Firmware 2.06.3 bug list:

List of bugs/improvement requests

FPGA design revision 83E9:

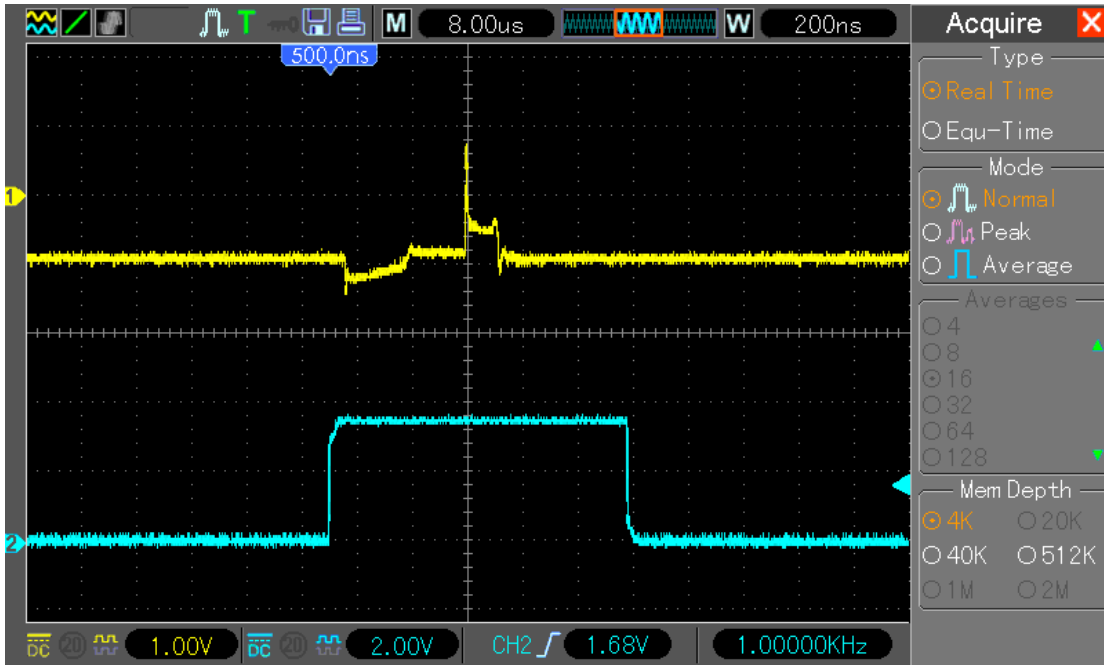
4. Digital Filters to be implemented.
5. SDK to be released
6. Update FPGA design to match ADC skew/timings in 125MHz/1GSs mode (this is already known issue and listed in old "issue list", posting once again in this list as reminder)
FPGA design revision 83E8 sample rate 1GS/s clocks skew (must be always 1000ps):

- Clock 8->Clock 1: 1010ps
 - Clock 1->Clock 7: 1250ps
 - Clock 7->Clock 2: 550ps
 - Clock 2->Clock 6: 1230ps
 - Clock 6->Clock 3: 1000ps
 - Clock 3->Clock 5: 1280ps

- Clock 5->Clock 4: 500ps
 - Clock 4->Clock 8: 1250psFPGA design revision 83E8 sample rate <= 800MS/s clocks skew (must be always 1250ps):
 - Clock 8->Clock 1 1250ps

Clock 1->Clock 7 1260ps
Clock 7->Clock 2 1280ps
Clock 2->Clock 6 1230ps
Clock 6->Clock 3 1260ps
Clock 3->Clock 5 1280ps
Clock 5->Clock 4 1230ps
Clock 4->Clock 8 1260ps

not yet measured, but Hantek statement *"It's impossible for us to achieve it now"*
is not really optimistic.

6. There is no affordable workaround for now. Changes to hardware are possible but expensive. I've tested Silicon Labs jitter cleaner, Murata LDHxxx delay lines and a combination of other solutions. I was more than satisfied with achieved results, expect the costs.
For now we have to use what available, both manufacturers developed within last 2 years few FPGA design versions, the best is from upcoming Tekway MST DSOs and Hantek Handhelds – however they not allowing dual channel 500MS/s sampling in long memory; Hantek's bench DSO hw1007 83E9 design allows such faster sampling but the skew is still far from perfect. I did publish all these FPGA designs, you can play with them to which is best for you. **But note – do not do this when you own hw1005 DSO, they can't be modified!**
For those of you who don't know what this bug means – Google for waveform/interleave distortion and/or Agilent 5989-5732EN.

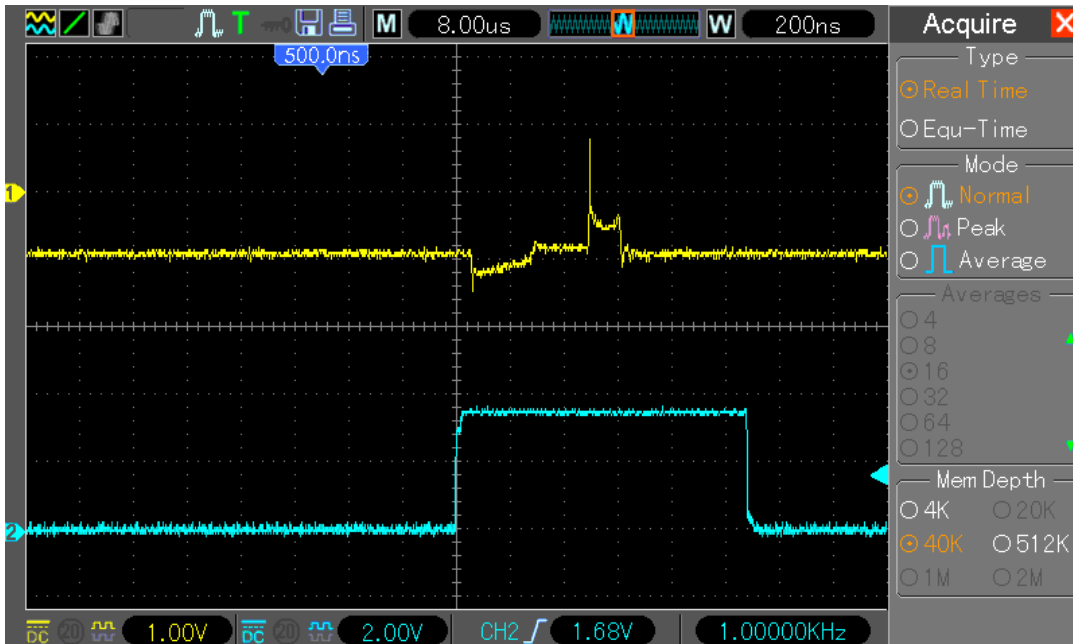
8. In single window, sample memory $\geq 40k$, both channels (ch1, ch2) enabled and time base from 400ns/div up to 2ns/div the position change (fine and coarse) control is not working. Only scale is moving, but not the waveform. See attached picture to understand issue:

with 4k memory when changing position waveform is moving

with 40k and above, when moving changing time base position waveform is NOT moving when in RUN mode (but works in STOP mode)

7. This is improvement proposal and not a bug. It has been removed from to-do as “not important”.
8. This is a very unfortunate bug; possible workaround is to use dual window mode or less memory depth (both with disadvantages)

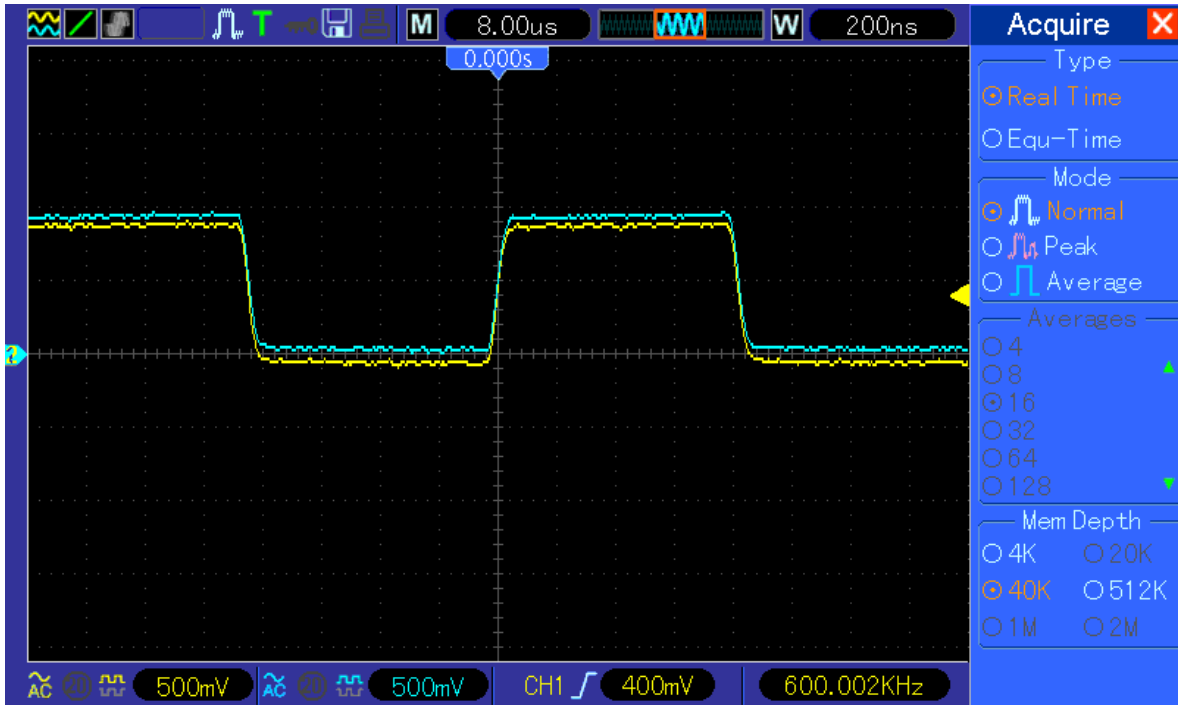
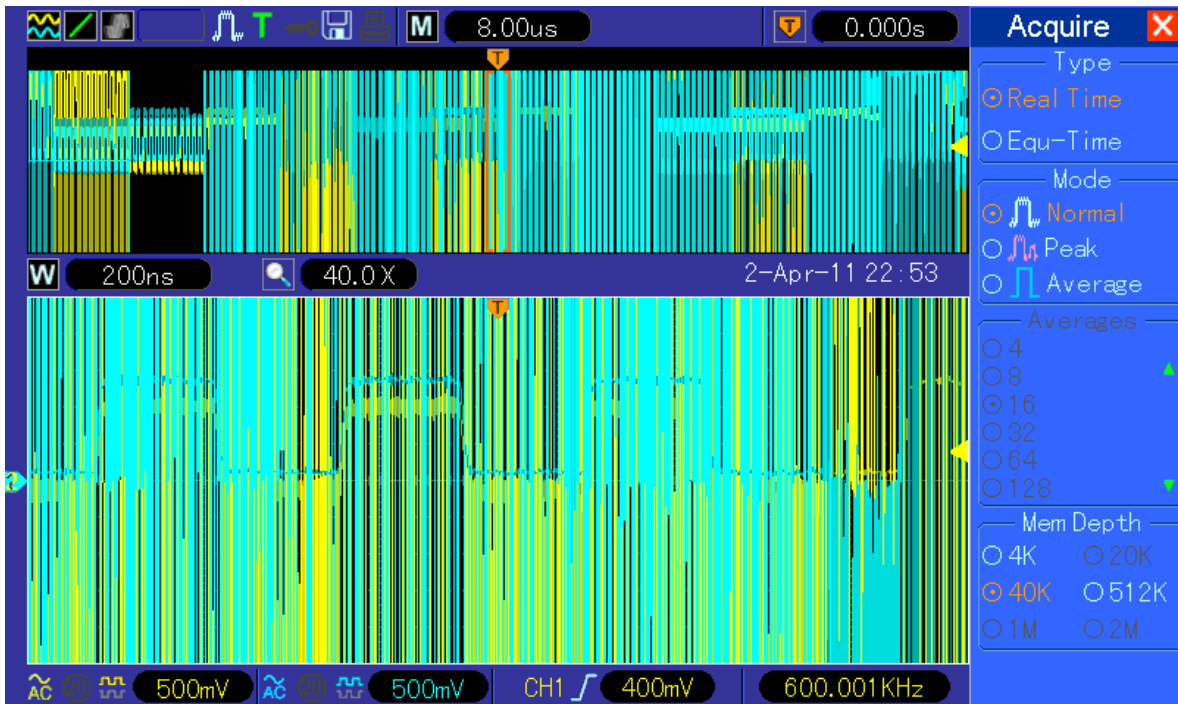
9. In single window mode, sample memory 40k, both channels (ch1, ch2) enabled – while switching to dual window mode artifacts on screen and DSO later crashing and not responding.

Artifacts disappear when changing timebase just after switch to dual window, so just an init error?

Set like on picture

and switch dual window mode to see artifacts like this:

9. ~~Workaround is to change Timebase (just one step forward and back) right after dual window enabled. Note – the main window (top) need to be activated, the bug have something to do with main TB buffer initialization.~~

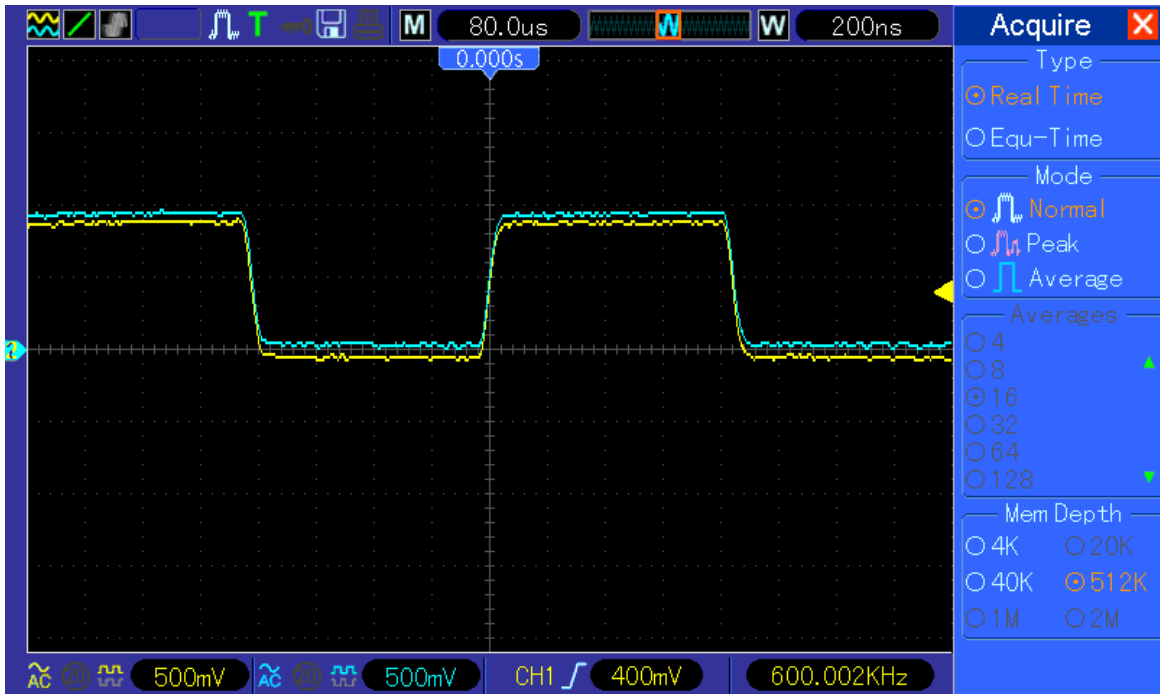
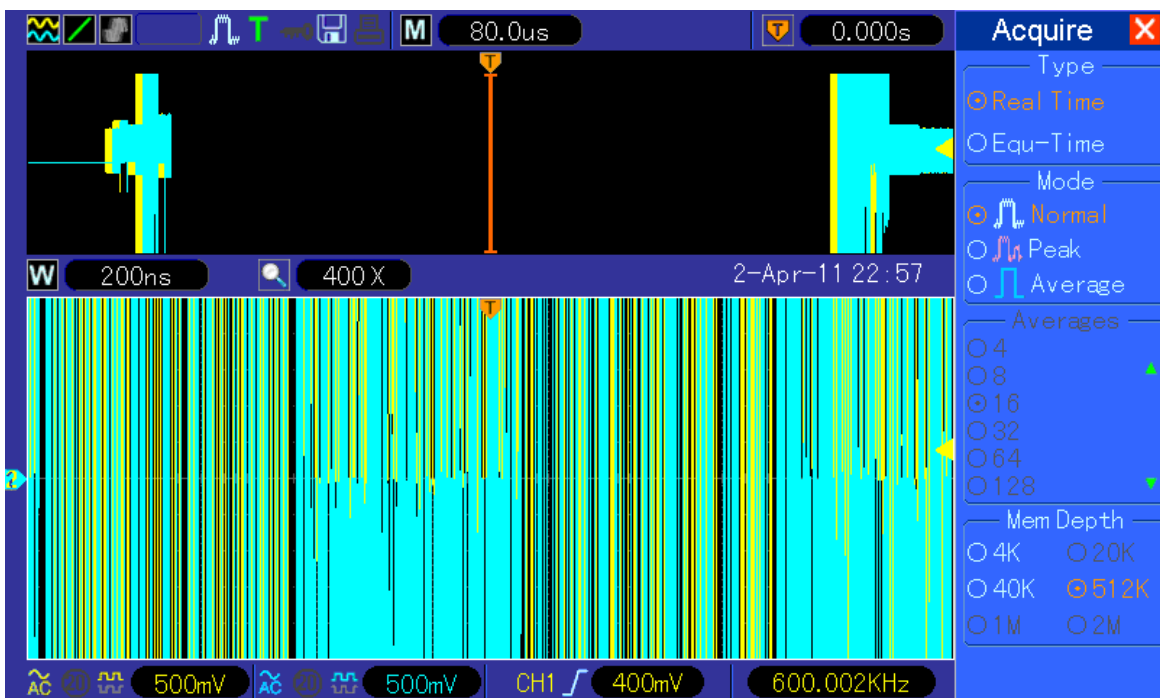
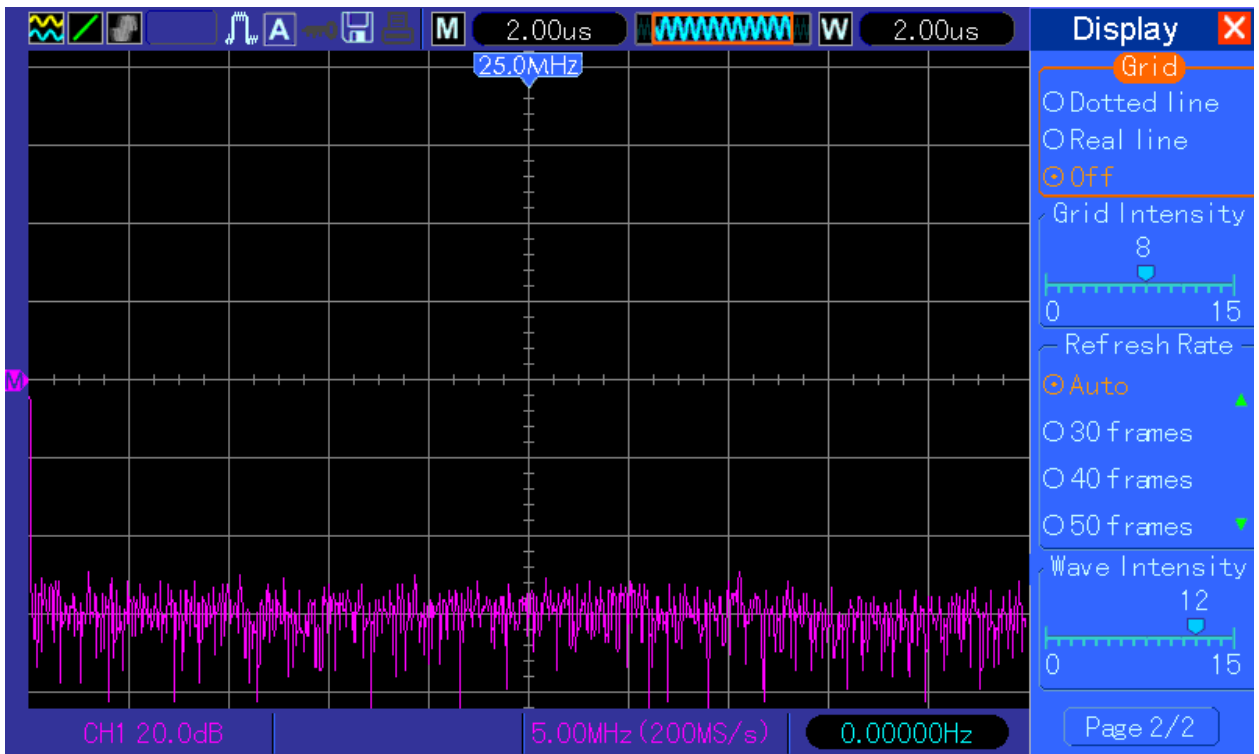
10. In single window mode, sample memory 512k, both channels (ch1, ch2) enabled – when switching to dual window mode artifacts on screen and DSO later crashing and not responding

Artifacts disappear when changing timebase just after switch to dual window, so just an init error?

Set DSO like on picture

and switch dual window mode to see artifacts like this:

10. Workaround is to change Timebase (just one step forward and back) right after dual window enabled. Note — the main window (top) need to be activated, the bug have something to do with main TB buffer initialization.
11. This is improvement proposal and not a bug.
12. Use my firmware (2.06.3_120507.6), I removed that bug.
13. Use DC trigger coupling or “add offset” when you set trigger point. On some other good known DSOs (e.g. Tektronix TDS7xxx) there is exact the same DC-signal/AC-trigger “dependency” (bug) and nobody ever complained about.

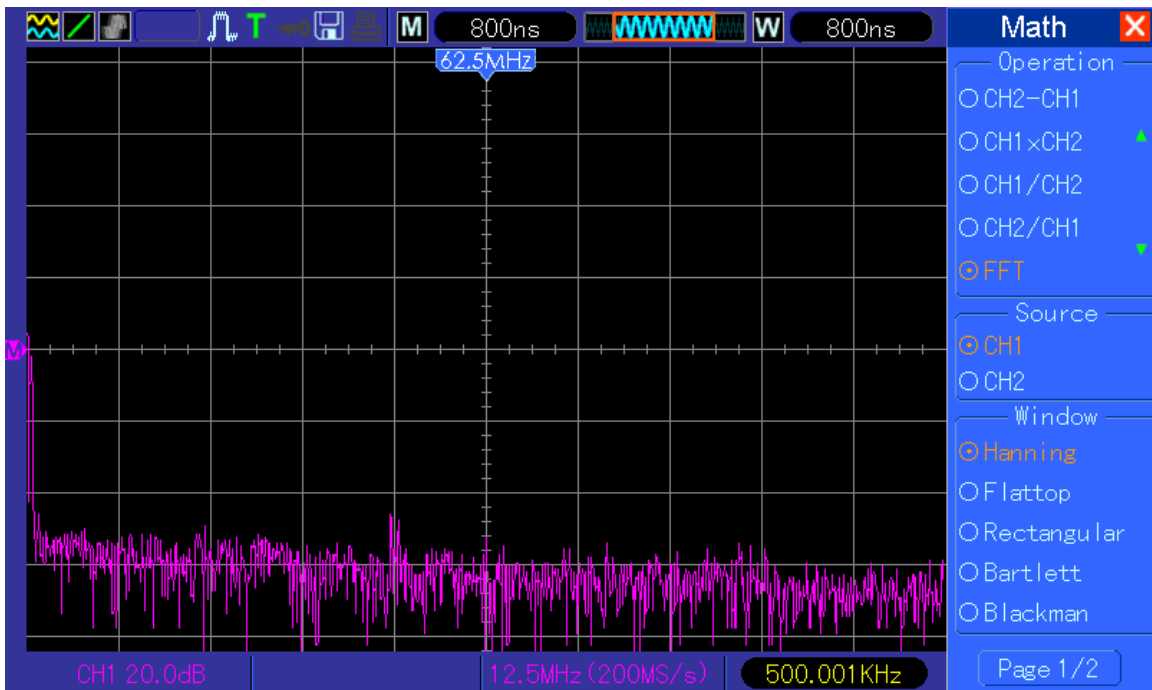
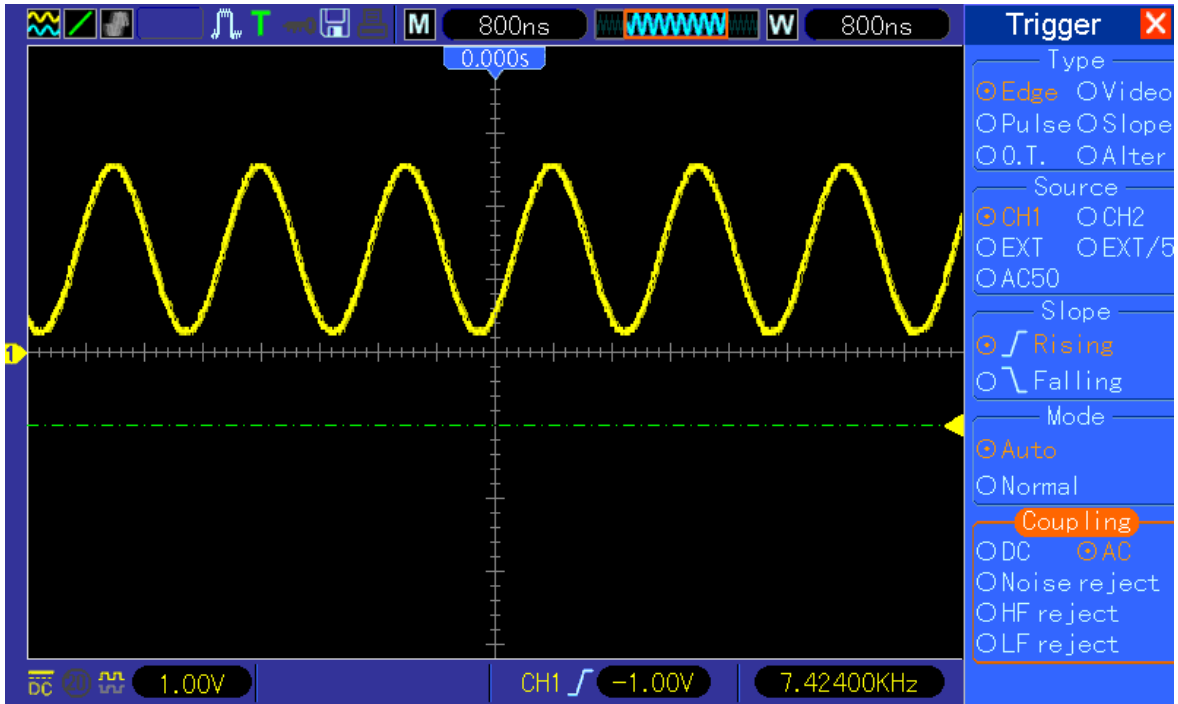
12. In FFT mode “Full span” is higher than Nyquist (sample rate / 2)

Example: 800ns/DIV, sample rate is 200MSs, full span 125MHz. Easy to fix by enabling from 800ns/DIV to 20ns/DIV 1GSs sampling (when 4k memory or FFT enabled)
